# Access Compliance Report Public Rights-of-Way (Curb Ramps)

| Main Street: STRAWFLOWER_ST | Cross Street: TRISTANIA_ST | Location: SE |

| ADA ID: RPAT211102133851 | Ramp Type: Type 4 - Parallel | Initial Pass/Fail: Fail | Overall Compliance: No | Severity Score: 2 |

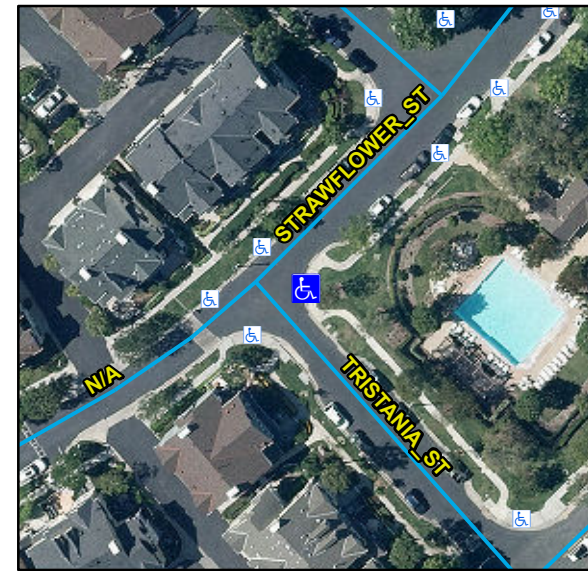
OC Std/PROW:  
**R204.3, R304.5.3, STD 1115**

| Compliance | Description                   | Data       | Compliance | Description                   | Data |
|------------|-------------------------------|------------|------------|-------------------------------|------|
| No         | Ramp Cross Slope LT (%)       | 3          | No         | Ramp Cross Slope RT (%)       | 3.3  |

Possible Solutions:  
**Remove & Replace Curb Ramp With Two New Directional Ramps or Equivalent.**
